HIGHWAY WORK PROPOSAL

<u>COUNTY</u>	<u>STATE PROJECT</u>	<u>FEDERAL</u>	<u>PROJECT DESCRIPTION</u>	<u>HIGHWAY</u>
Sheboygan	1440-13-72	N/A	Fond Du Lac - Plymouth; WCL - CTH P	STH 023

Addendum No. 03
ID 1440-13-72
Revised Sheet 5
January 10, 2020

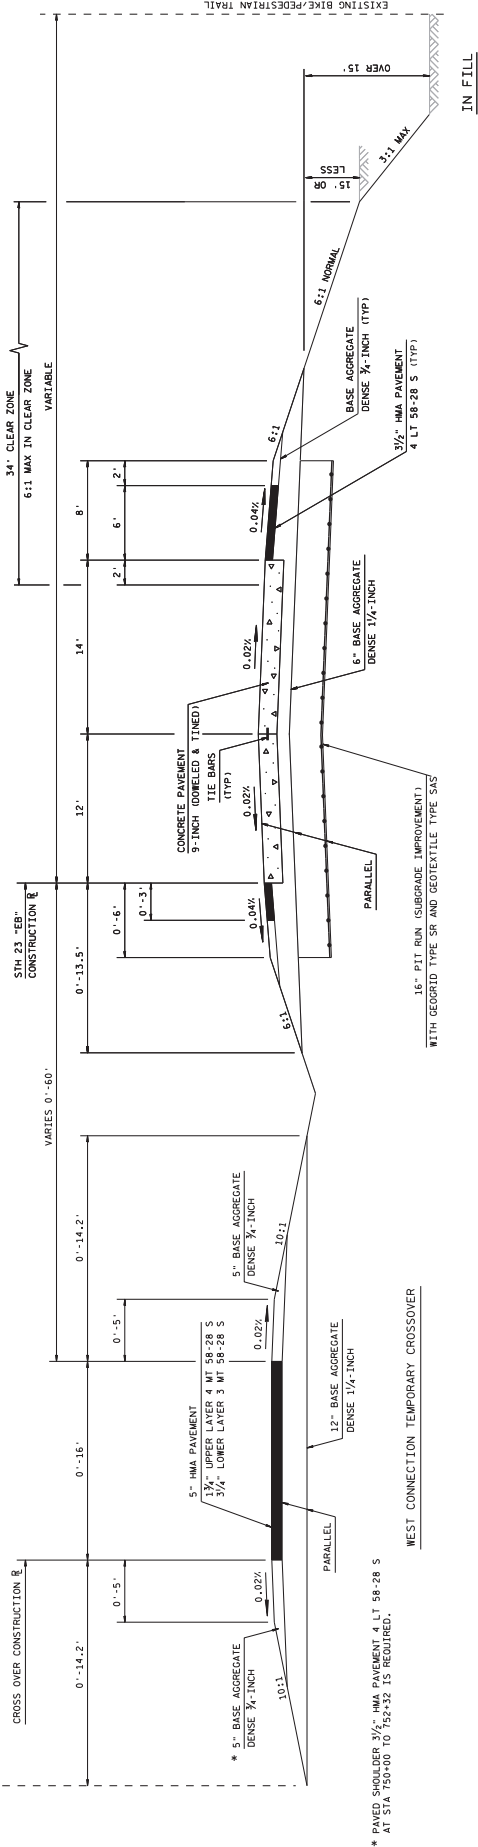
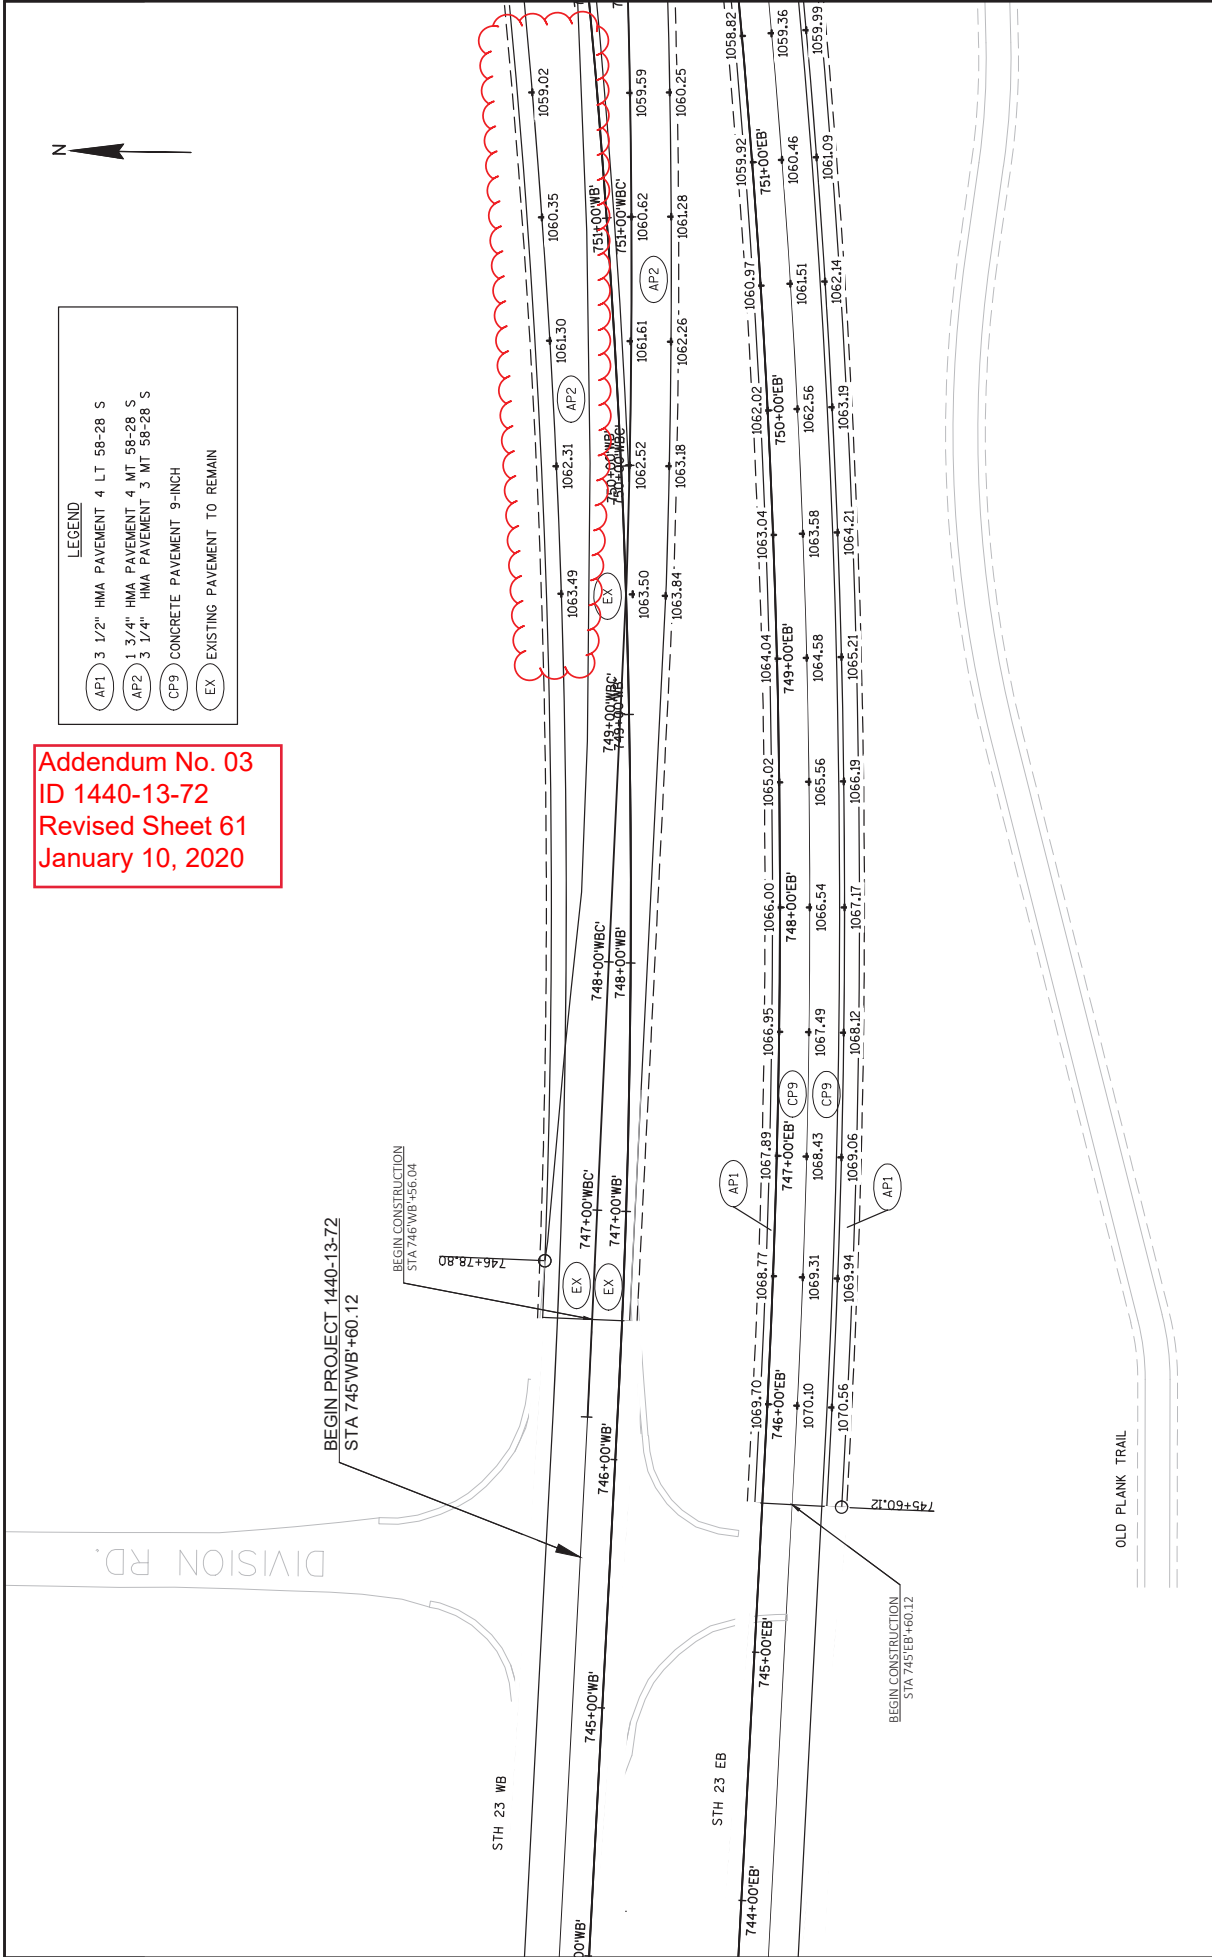
* PAVED SHOULDER 3/4\"/>

AT STA 750+00 TO 752+50 IS REQUIRED.

Addendum No. 03
ID 1440-13-72
Revised Sheet 573
January 10, 2020

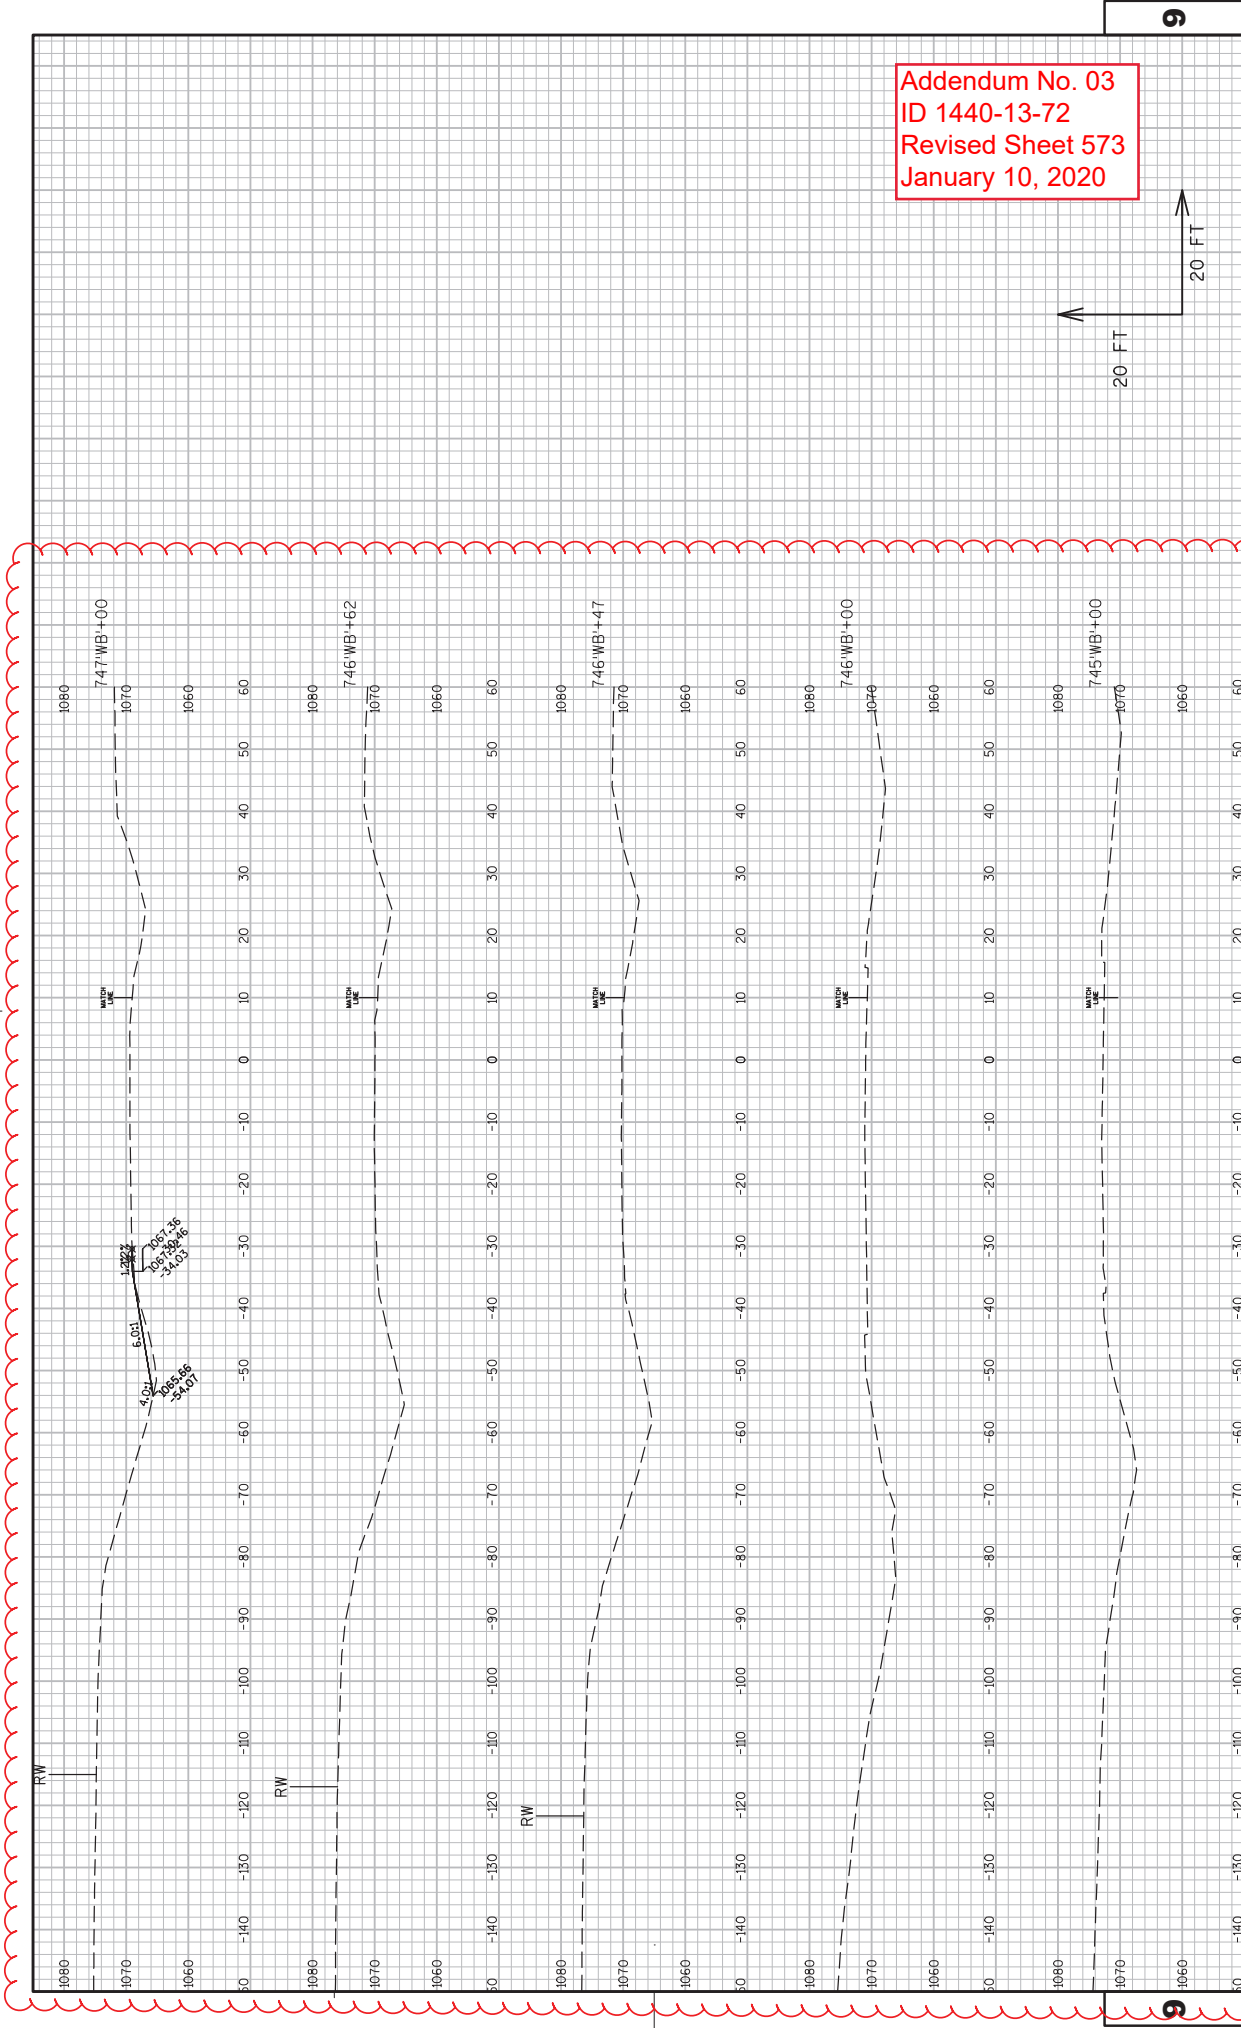
GRADE TO EXISTING DITCH ELEVATION
DONE BY PREVIOUS PROJECT ID 1440-13-16

Addendum No. 03
ID 1440-13-72
Revised Sheet 574
January 10, 2020

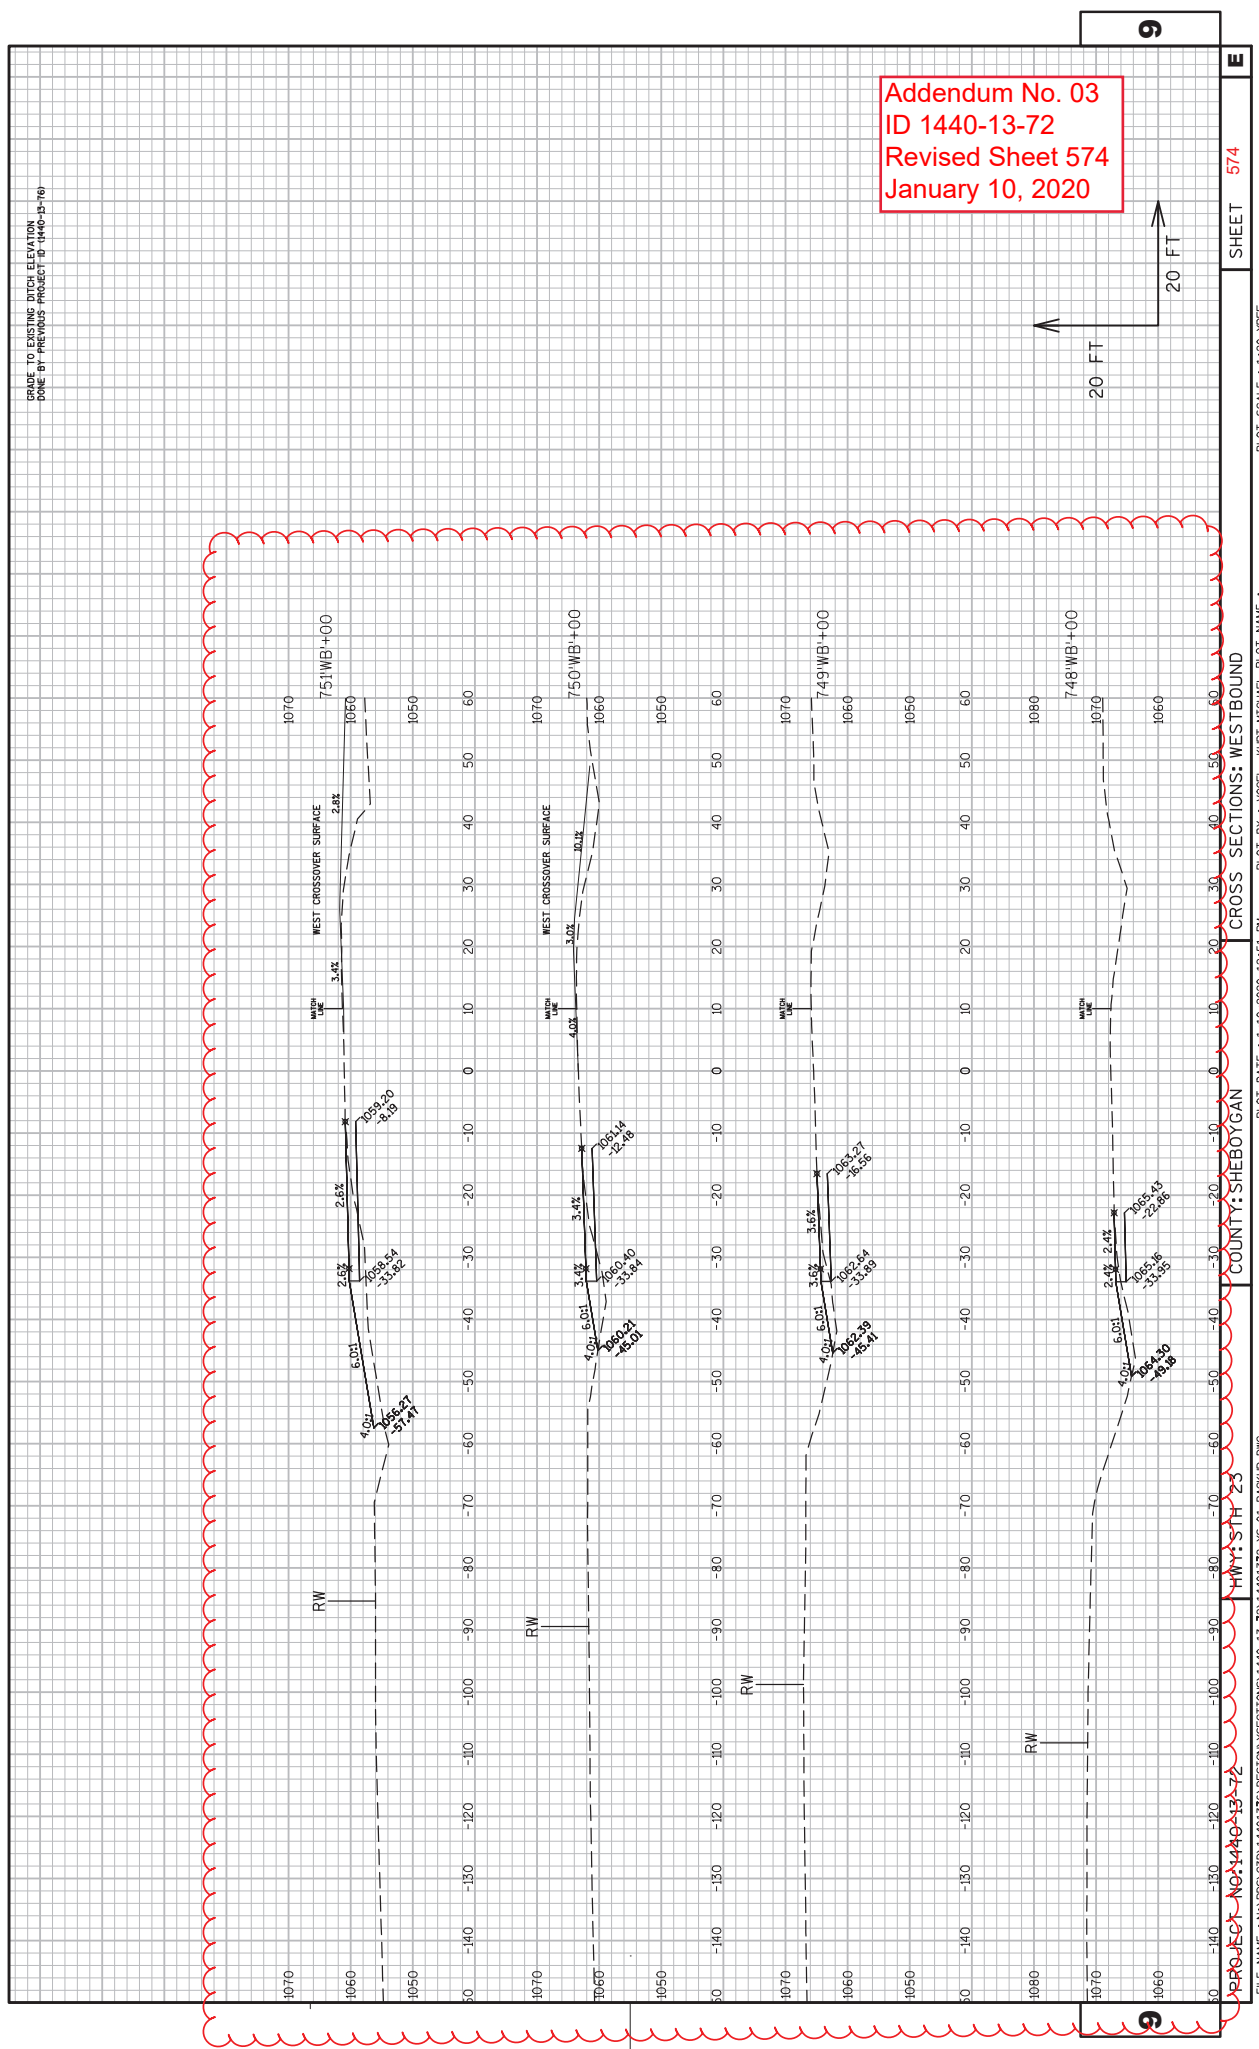
GRADE TO EXISTING DITCH ELEVATION
DONE BY PREVIOUS PROJECT ID 1440-13-76

Addendum No. 03
ID 1440-13-72
Revised Sheet 575
January 10, 2020

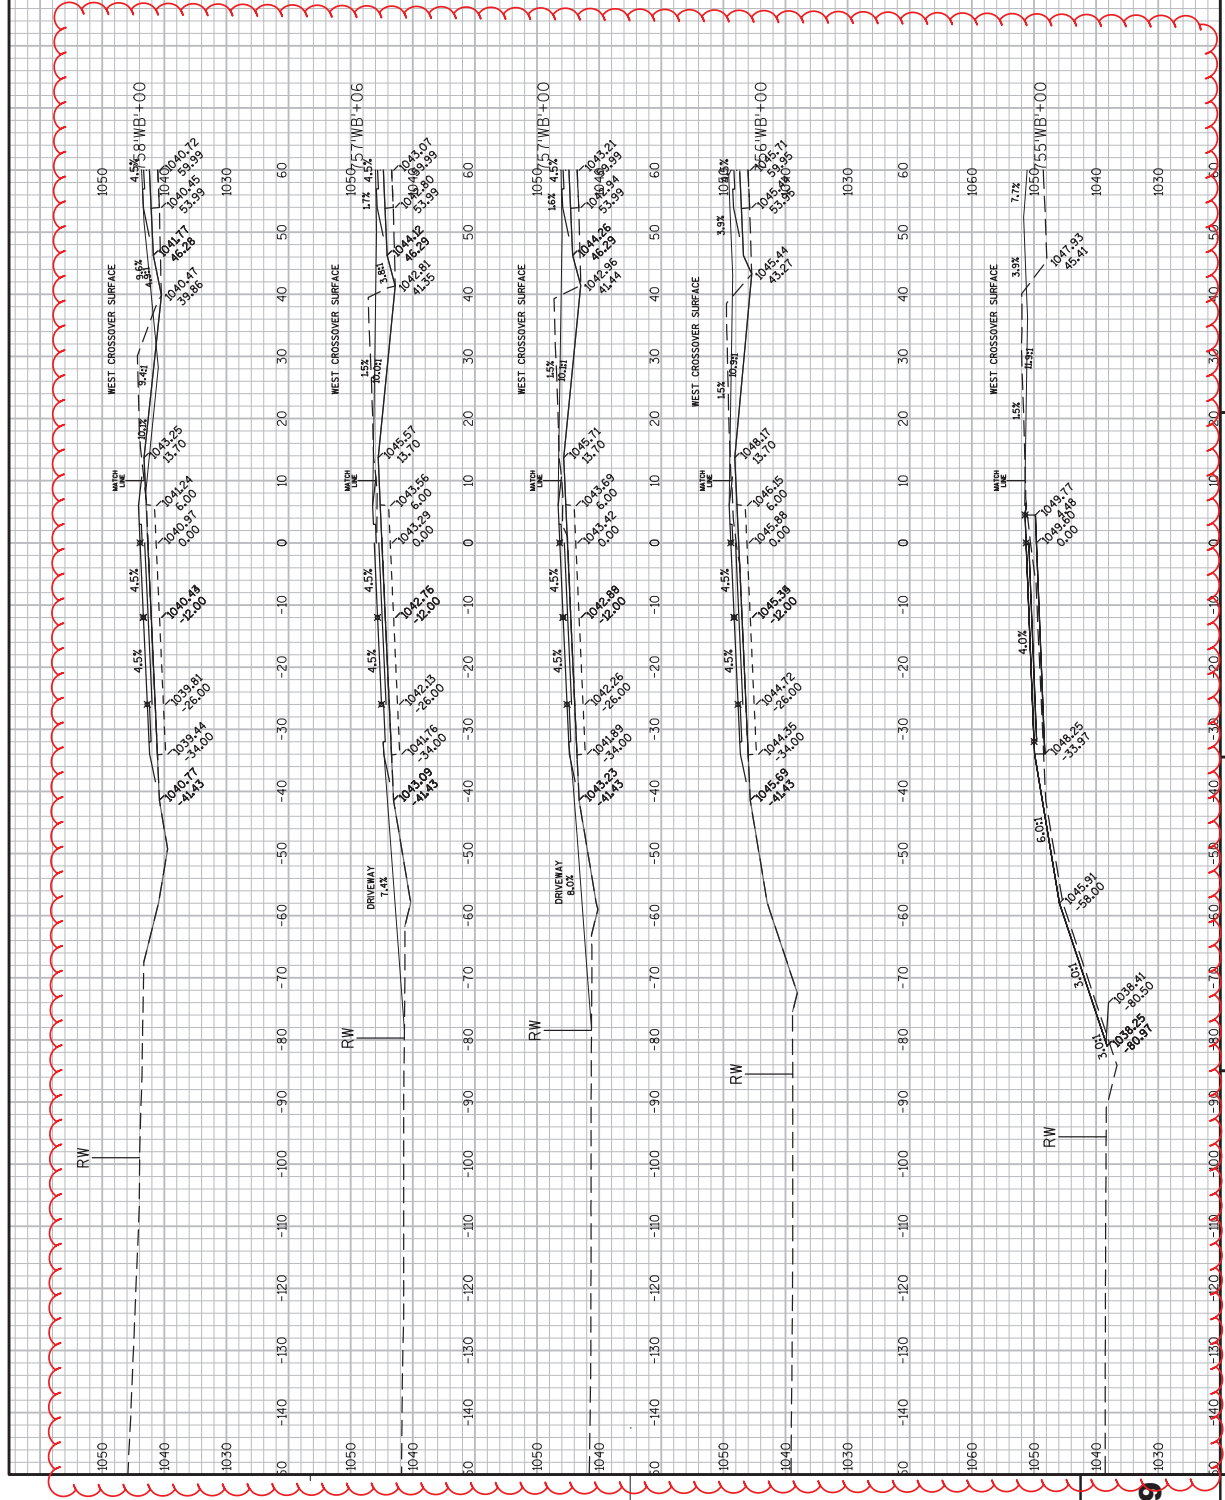
GRADE TO EXISTING DITCH ELEVATION
DONE BY PREVIOUS PROJECT ID 1440-5-16
